UNITED STATES PATENT AND TRADEMARK OFFICE

10/560,365

Office Action Summary	Application No. 10/560,365	Applicant(s) HIWATA ET AL.	
	Examiner MARY A. DAVIS	Art Unit 3748

DETAILED ACTION

Marked up top half of Figure 3 of YOSHIYUKI ET

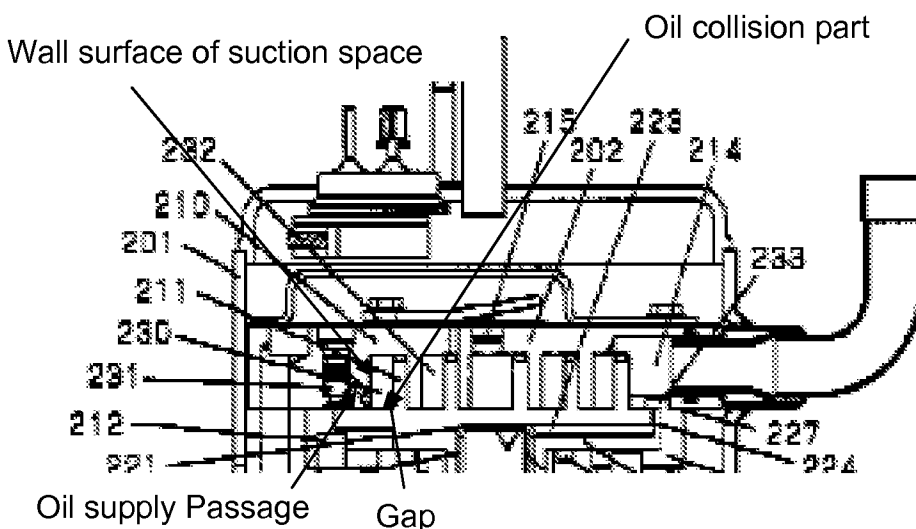
- a gap is formed between said oil collision part and a wall surface of said suction space (see marked up Figure 3 of YOSHIYUKI ET AL below; see marked up Figures 15 and 16 of FUJIO ET AL below; see marked up Figure 4 of HIWATA ET AL below).

Marked up Figure 15 of FUJIO ET AL.

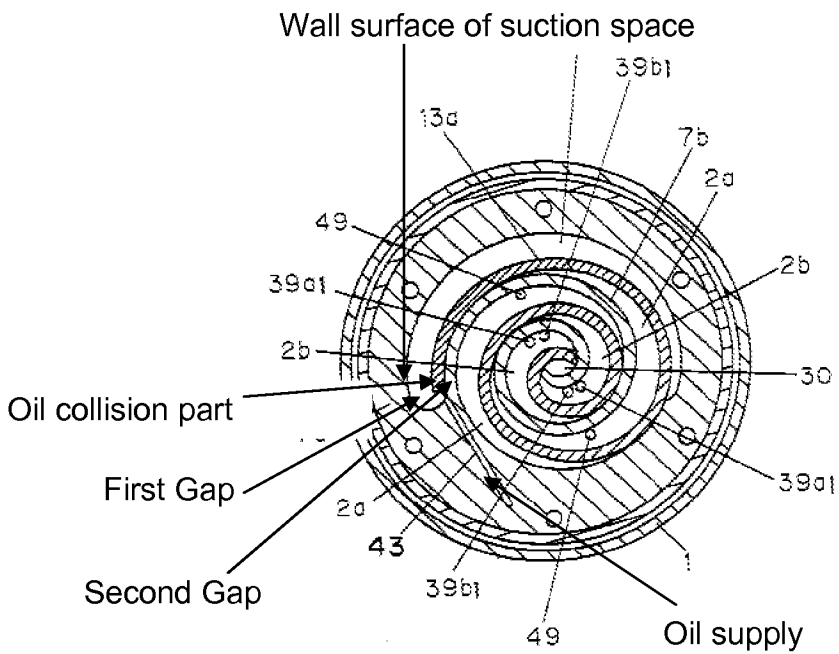
- said gap comprises a first gap (see marked up Figure 15 above) formed from said oil supply passage toward a suction pipe and a second gap (see marked up Figure 15 above) formed from said oil supply passage toward said compression chamber (see marked up Figure 15 above), and said first gap is greater than said second gap (see marked up Figure 15 above).

Marked up Figure 16 of FUJIO ET AL.

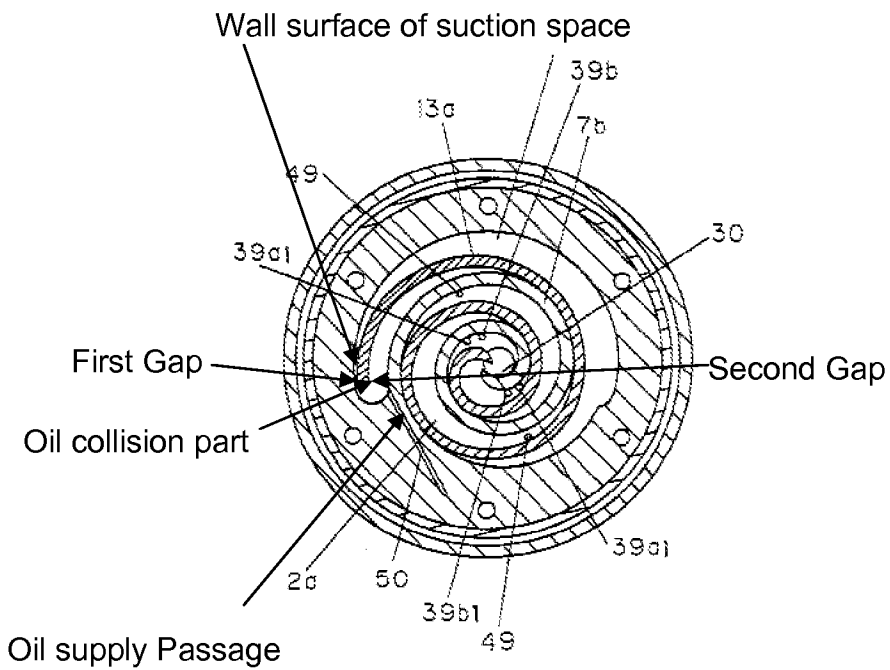
- said gap comprises a first gap (see marked up Figure 16 above) formed from said oil supply passage toward a suction pipe and a second gap (see marked up Figure 16 above) formed from said oil supply passage toward said compression chamber, and said second gap is greater than said first gap (see marked up Figure 16 above).
